LR-N08-0149

Subject: **RESPONSE TO REQUEST FOR ADDITIONAL INFORMATION -  
REQUEST FOR CHANGES TO TECHNICAL SPECIFICATIONS  
REFUELING OPERATIONS – DECAY TIME  
LICENSE AMENDMENT REQUEST (LAR) S08-01**

REQUEST FOR ADDITIONAL INFORMATION  
REGARDING PROPOSED LICENSE AMENDMENT  
DECAY TIME TECHNICAL SPECIFICATION REQUIREMENTS  
SALEM NUCLEAR GENERATING STATION, UNIT NOS. 1 AND 2  
DOCKET NOS. 50-272 AND 50-311

# **Salem Decay Time Technical Specification Requirement License Amendment: Assessment of RAI Questions 1.a and 1.b**

**Figure 3. Comparison of CROSSTIE Results to Hand Calculation Results**

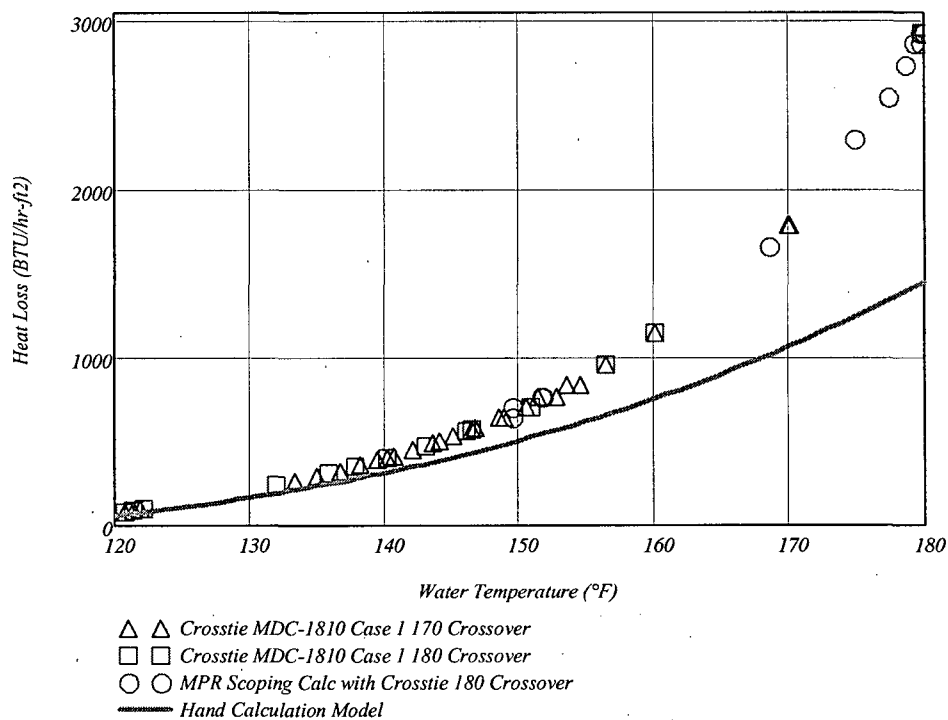
Figure 3 also shows the heat loss calculation result for the hand calculation model. The comparison shows that CROSSTIE calculates more heat loss from the spent fuel pool surface than the hand calculation model.

CROSSTIE was calibrated against plant data in References 8 and 11. This calibration was for a SFP temperature in the range of 80 to 140°F (Reference 8, Appendix A, Pages 3 and 4, and Reference 11, Figures 5.3 and 5.4). The calculation with the Ryan-Harleman correlation assumes perfect mixing of the SFP, i.e., the surface temperature and the bulk temperature are the same. Figure 3 shows agreement of CROSSTIE and the hand calculation model in the 120 to 140°F temperature range. Based on Figure 3, CROSSTIE over predicts heat transfer from the pool surface at temperatures above approximately 140°F.

**Figure 4. Unit 1 and Unit 2 Spent Fuel Pool Temperature vs. Time  
(adapted from Reference 7)**

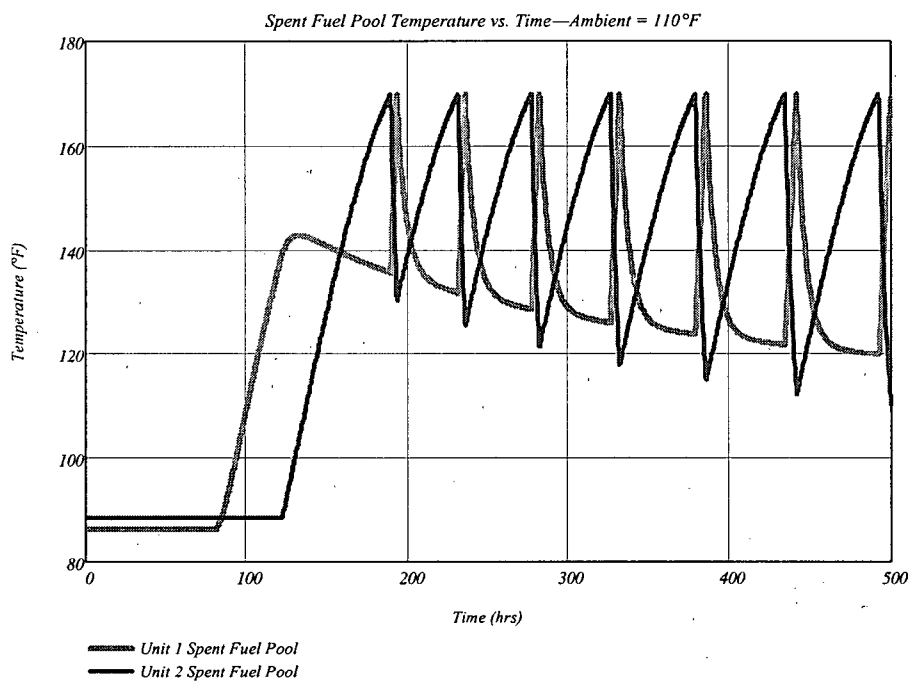
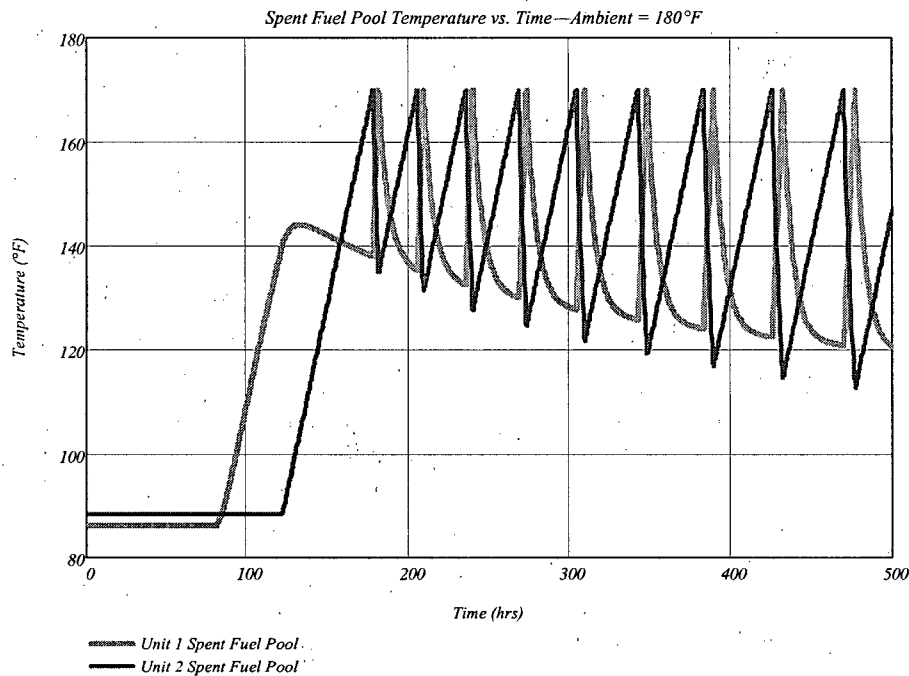
Figure 4 shows that when the cooling flow is aligned to the Unit 2 SFP, the temperature in the Unit 1 spent fuel pool rises quickly. The time to rise from a temperature of about 137 to 170°F is on the order of 4 hours. When the cooling flow is aligned to the Unit 1 SFP, the time for the Unit 2 pool to heat up from about 130°F to 170°F is about 40 hours. The difference in heat up time is due to the difference in decay heat from the spent fuel in the two pools.<sup>1</sup>

A scoping calculation was made with CROSSTIE to assess the effect of having no heat transfer from pool surface. The calculation presented in Reference 7 was duplicated with one change: the air temperature was increased from 100°F to 180°F to eliminate heat loss from the pool surface. Figure 5 provides the transient temperature results for the Unit 1 and Unit 2 spent fuel pools.

Based on these results, an option that PSEG Nuclear can pursue is to revise the calculations that support the licensing amendment to use an air temperature of 180°F. This will eliminate heat transfer from the pool surface and thereby eliminate NRC concern with the evaporation correlation used by CROSSTIE. The scoping calculation results provided in Table 5 show that the switchover times with this calculation approach are likely within the capability of the Salem operators.

Figure 6. Comparison of Reference 4 Evaporation Data to the ASHRAE Correlation

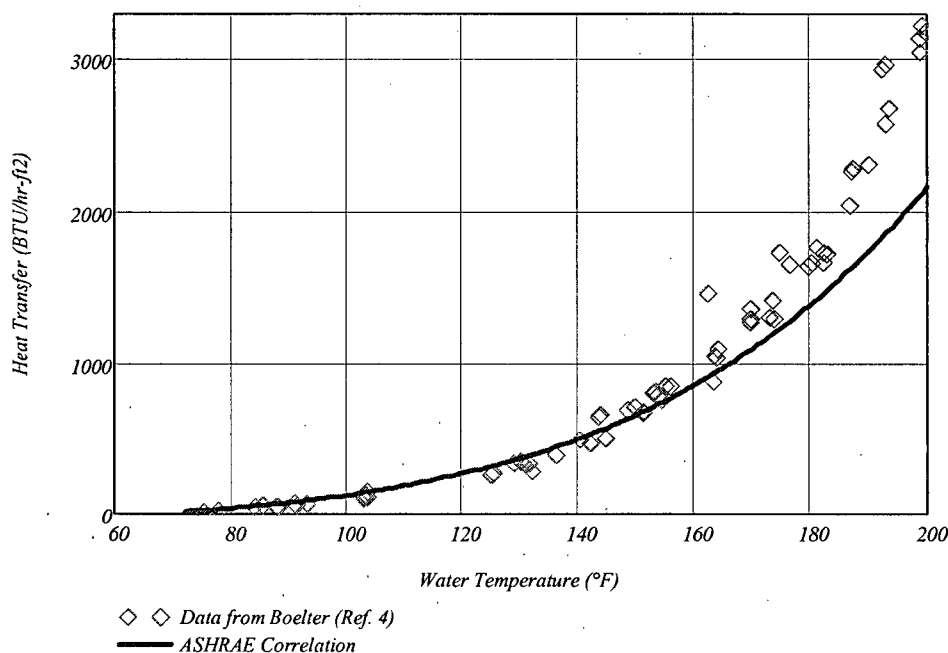
Figure 6 compares the ASHRAE correlation to the evaporation data in Reference 4. As shown, the ASHRAE equation under predicts evaporation at pool temperatures above 160°F.
